Review of Plans: Lidl Supermarket. 3-58 Route 303, Tappan, NY

Subject: **Tappan Plaza Site Plan**
3-58 Route 303, Tappan
77.15/1/33-37 & 41; CS, LIO and Route 303 Overlay zoning district

Submission Reviewed:

Site Development Plans as prepared by Bohler Engineering last revised 8/4/2020, C-03, C0-4, C0-5.

SHEET TITLE:
OVERALL SITE PLAN
SHEET NUMBER:
C-03
OF 25
REVISION 5 - 8/4/2020

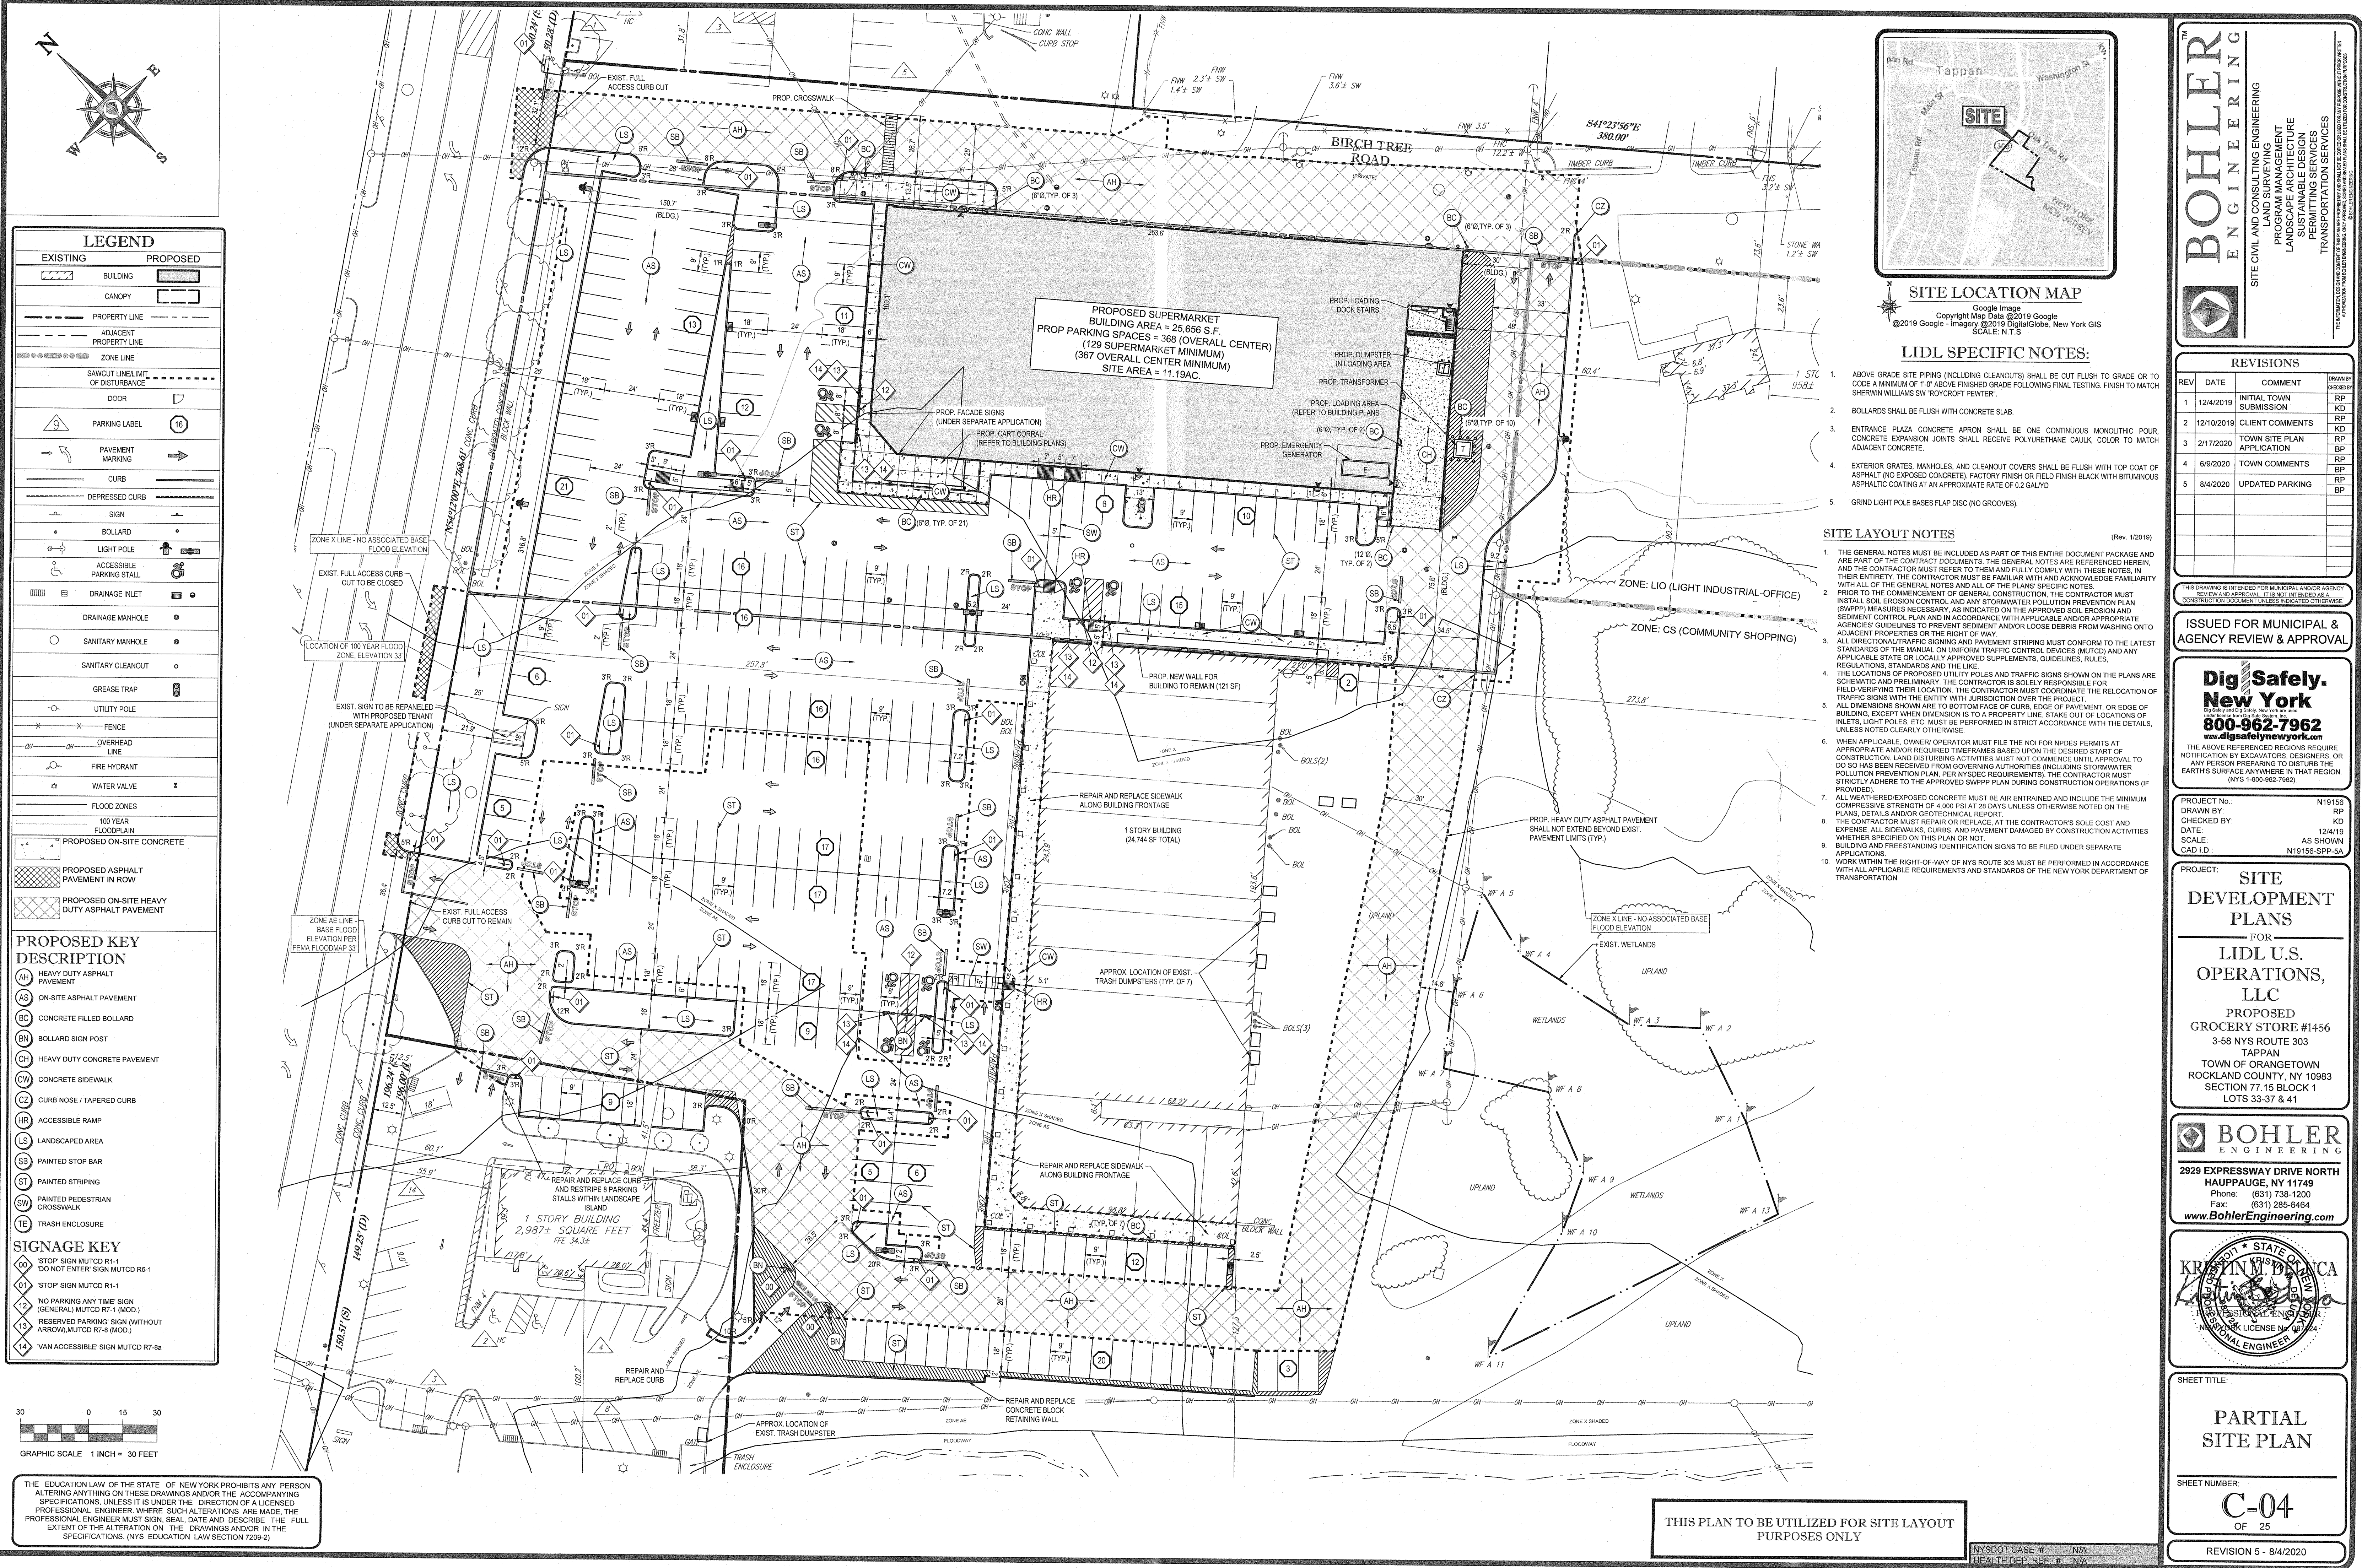
- 1) Applicant must provide information related to the proposed easement(s) for parking and ingress/egress over the existing residential lot #33 as shown.
- 2) The following variances are required:
 - a) Per Section 13.10 B (2), "A twenty-five-foot wide vegetated buffer, either containing native vegetation naturally occurring and/or containing shrubs and/or trees a minimum of six feet high, with such shrubs and/or trees as listed under the provisions of § 21.25 of the Land Development Regulations of the Code of the Town of Orangetown at time of planting shall be located along the property line adjacent to the Route 303 right-of-way."

No vegetation is shown proposed within the 25-foot buffer, a variance is required.

- b) Per Section 13.10 B (3), "Any nonresidential use that is adjacent to a residential zoning district shall include a 25-foot wide vegetated buffer."

No vegetative buffer is shown between the proposed supermarket lot and the existing residential lot number 33, a variance is required.

- c) Per Section 13.10 B (10), " Not more than 35% of all parking shall be located within the front yard of any lot or parcel.

Variances are required for the following:

121 stalls (80.1%) to be located within the front yard for the overall site.
